SUBJECT: Princeton University - Campus Operations Building
Preliminary and Final Site Plan Application Review
Planning Board Review Memo #1
PB22-06
Block 3, Lot 1.012
West Windsor Township, Mercer County, New Jersey

Subject: Trustees of Princeton University – Campus Operations Building
Preliminary and Final Site Plan
Block 3 Lot 1.012
Nursery Road and Lower Harrington Street

SUBJECT: Trustees of Princeton University-Campus Operations Building (PB 22-06)
Preliminary/Final Major Site Plan
Block 3 Lot 1.012
VCEA Project No. 22-12-WW

SUBJECT: **Trustees of Princeton University
Preliminary/Final Major Site Plan – “Lake Campus Operations Building”
Planning Board Submission #1
Block 3, Lot 1.012 – “Lake Campus North”
Nursery Road & Lower Harrison Street
PB 22-06**

Figure 1: Nonresidential Square Footage

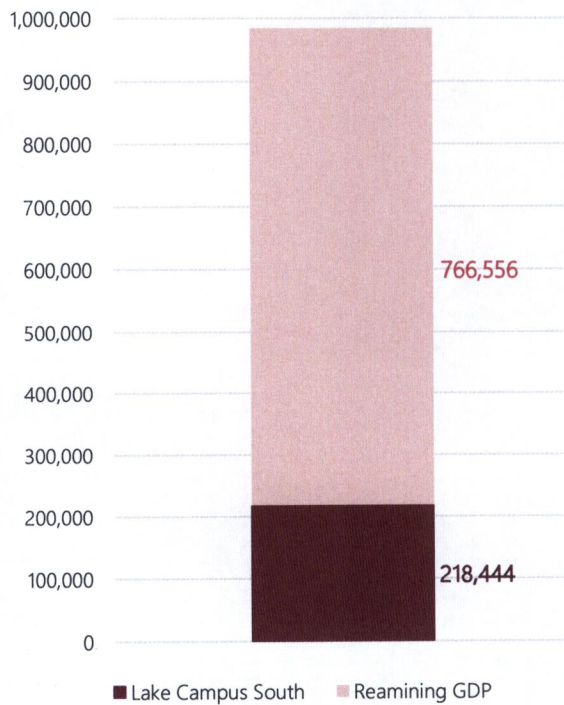
1. Comparison with the previously approved GDP. The proposed Operations Building development appears to coincide with what was envisioned during the GDP process. This should be confirmed through testimony.
2. GDP Tracking Table. The applicant has provided a GDP tracking table on Sheet CS-004. This table, which is summarized on the following page, compares the proposed nonresidential square footages and residential units by campus phase to what was approved in the GDP.
